Our Ref: CSGA-C2129-T1

Re: Sound Insulation Review of Replacement Cladding - 56 High Street

1 Façade Sound Insulation Review

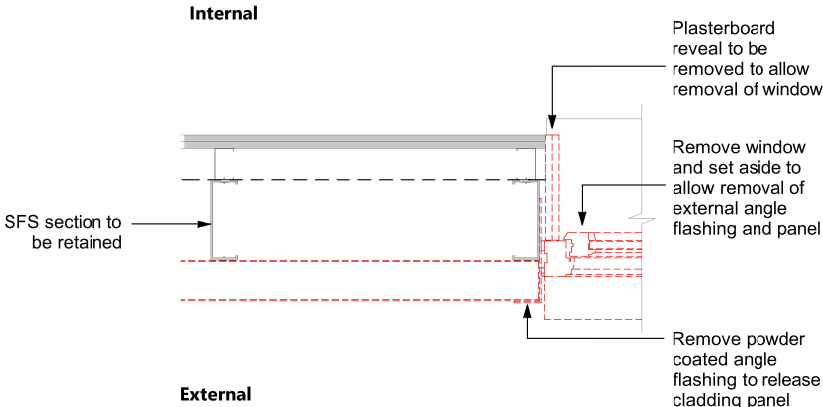
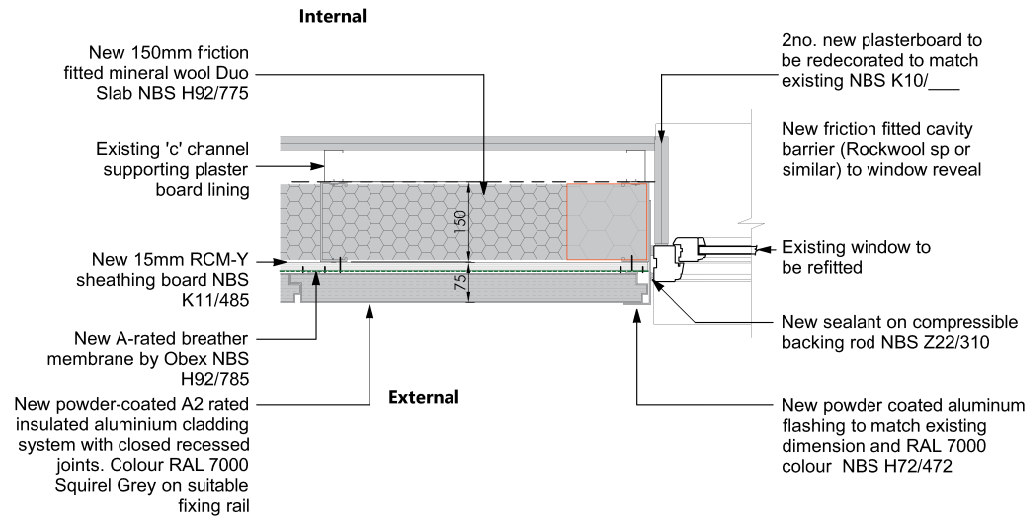
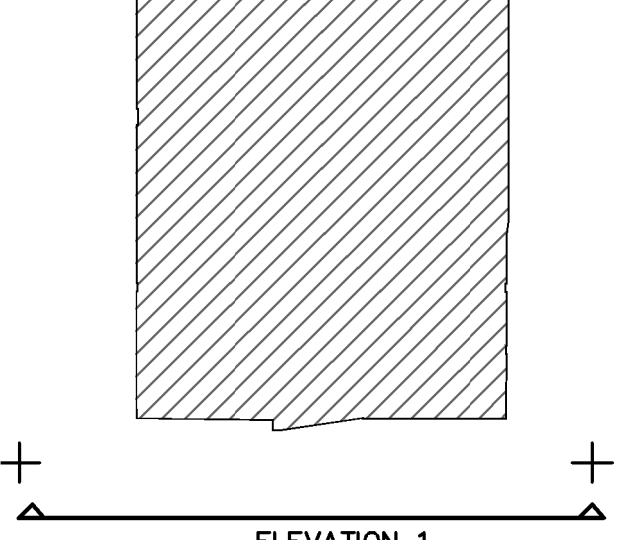
Cladding at Penthouse level/roof level is being replaced. The existing Insulated aluminum sandwich panel is being removed and replaced with a new insulated aluminum cladding, sheathing board and mineral wool insulation. As shown in drawing '5540-HMA-HS-ZZ-DR-A-21101_P1 External Wall Treatment - Cladding at Rood Level' appended to this letter. All existing windows will be refitted and resealed.

Façade Type	Cladding Details		Sound Insulation Prediction
Penthouse/ Roof level Cladding Existing Insulated sandwich panel	Existing	75mm Insulated Aluminium sandwich panel 150mm SFS Section 'c' channel (~50mm) - Stud spacing ~500mm 2 x 12.5mm Plasterboard	R_w 51 dB C_{tr} -3 dB $R_w + C_{tr} =$ 48dB
Penthouse/ Roof level Cladding New cladding system	Proposed	- New 75mm Insulated aluminium cladding system with recessed joints 15mm Sheathing board (RCM) 150mm mineral wool slab - Existing 'c' channel 2 new 12.5mm plasterboard layers as per original specification - Existing windows refitted and sealed - New cavity barrier installed (Rockwool)	R_w 53 dB C_{tr} -2 dB $R_w + C_{tr} =$ 51 dB

As seen in the table above, the calculated sound insulation performance of the elements of the façade which are to be changed show a slight improvement in performance.

This therefore demonstrates that provided the reinstalled windows are suitable sealed and all elements are suitably installed, the overall façade sound insulation will not show any degradation in terms of sound insulation performance.
